Midway City Council  
20 July 2021  
Work Meeting

Resolution 2021-13 /  
Street Cross-Sections

**To: Mayor Johnson and City Council**  
**From: Wes Johnson**  
**Date: July 16, 2021** **Memorandum**  
**Subject: Memo Regarding Midway City Standard Roadway Widths**

### **A RESOLUTION BY THE MIDWAY CITY COUNCIL ADOPTING AN UPDATED STANDARD SPECIFICATIONS AND DRAWINGS FOR THE CITY OF MIDWAY**

**LOCAL STREET CROSS SECTION #1  
COMMERCIAL & BUSINESS**

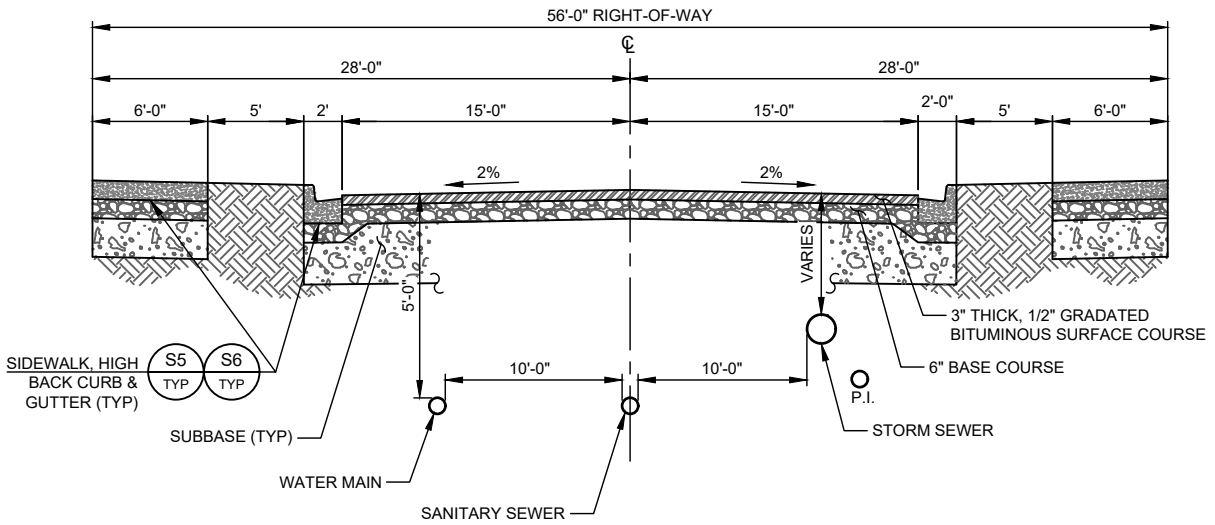
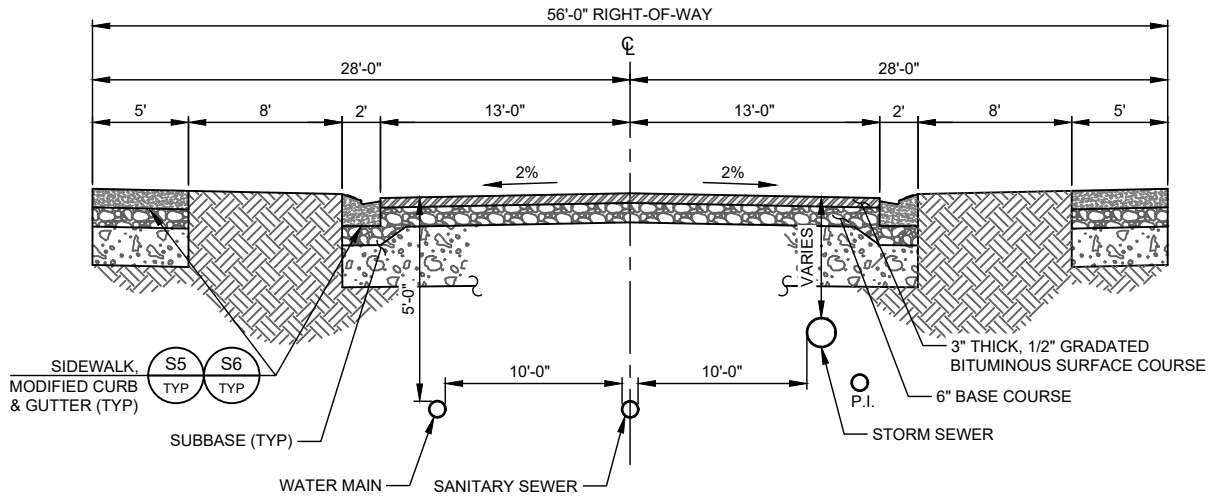
1. Local Street Cross Section #1 for Commercial Business
  - a. It is proposed to leave the asphalt cross section as shown. This will accommodate parking and allowing vehicles to open doors without causing issues for cars driving on the street.

**LOCAL STREET CROSS SECTION #2**

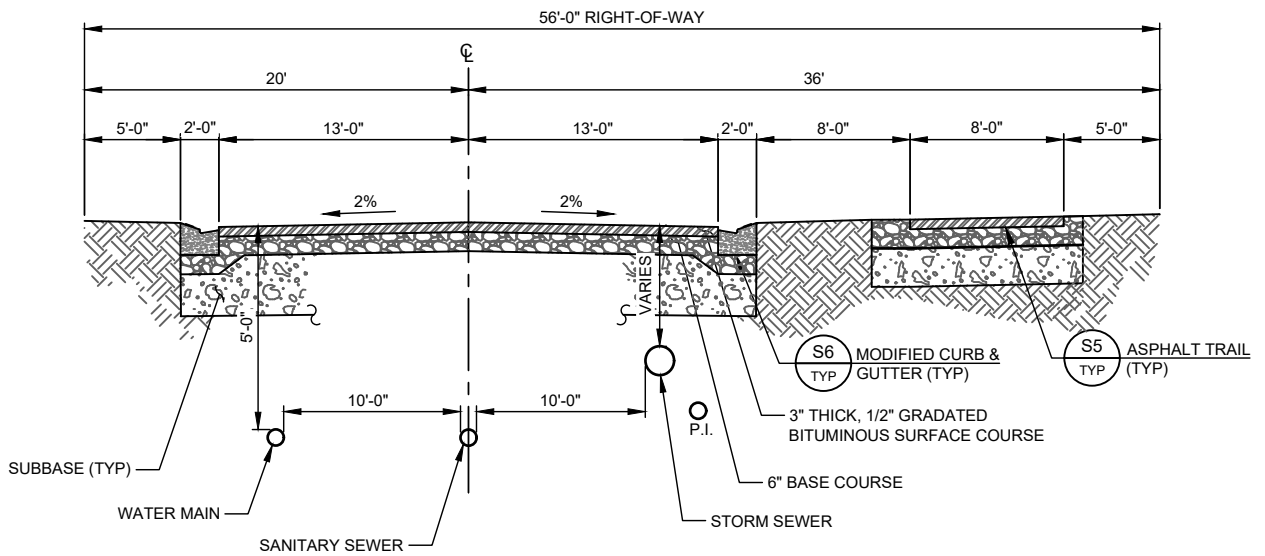
2. Local Street Cross Section #2
  - a. Reduce the required cross section width of asphalt from 30' to 26'.
  - b. Take the reduction in asphalt width and add it to the park strip. This would take the park strip from 5' wide to 7' wide.

LOCAL STREET CROSS SECTION #3

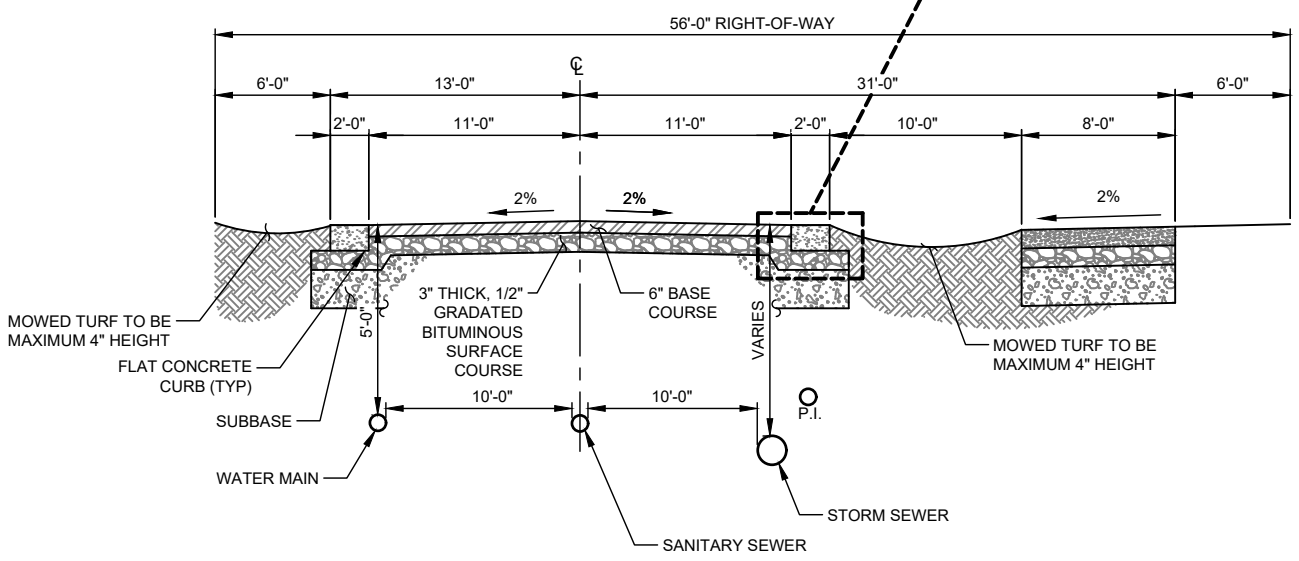
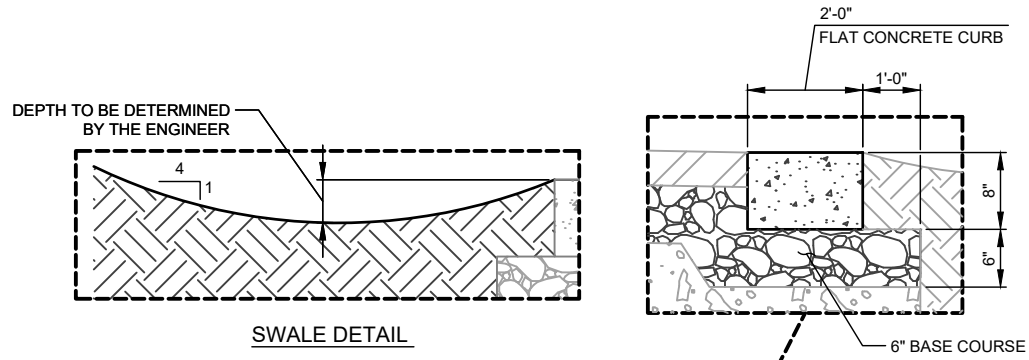
3. Local Street Cross Section #3
  - a. Reduce the required cross section width of asphalt from 30' to 26'.
  - b. Take the reduction in asphalt width and add it to the park strip.

- c. With a only a trail on one side of the road.
  - d. The road is shifted to the left so that the left side of the cross-section distance from the curb and gutter to the ROW equals the right-side distance of the outside edge of the trail to the ROW.

**LOCAL RURAL STREET CROSS SECTION #4**

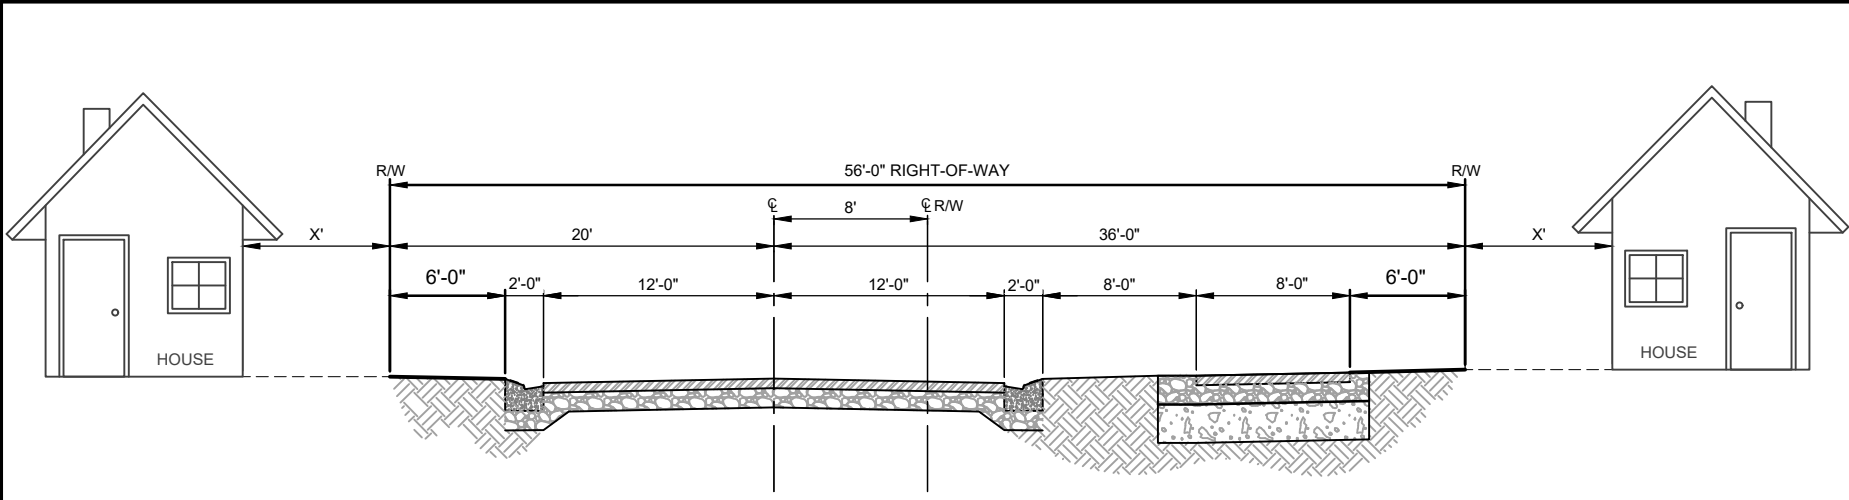
4. Local Rural Street Cross Section #4
  - a. To qualify for this cross section the frontage requirement has been reduced from 150' to 105' and must be approved by City Council.

- b. Reduce the required cross section width of asphalt from 30' to 20'. With a 2' ribbon curb on each side.
  - c. Take the reduction in asphalt width and add it to the park strip.

- d. With a only a trail on one side of the road.
  - e. The road is shifted to the left so that the left side of the cross-section distance from the curb and gutter to the ROW equals the right-side distance of the outside edge of the trail to the ROW.

We met with Councilmen Simons, Councilmen Payne, and the planning staff regarding the Midway City standard roadway widths. The engineering department supports the proposed changes however our recommendation for local rural street asphalt cross section be increased from 20' to 22' of asphalt. Below is a summary of our discussion with the attached cross sections:
